Offshore Wind ORTP Calculation RENEW Amendment on Capital Costs and Tax Credit Assumptions

For NEPOOL Markets Committee | November 9 -10, 2020

A Decade of Falling New England Offshore Wind Prices

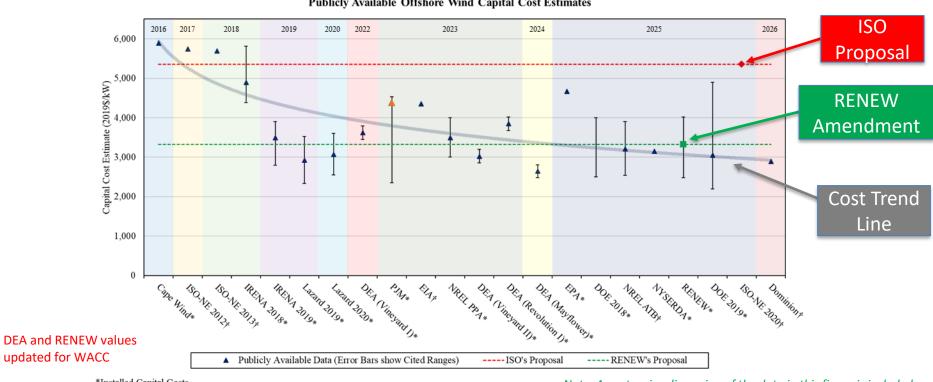
In 10 years there has been a 70% reduction in local offshore wind contract prices driven by both capital and operating cost reductions
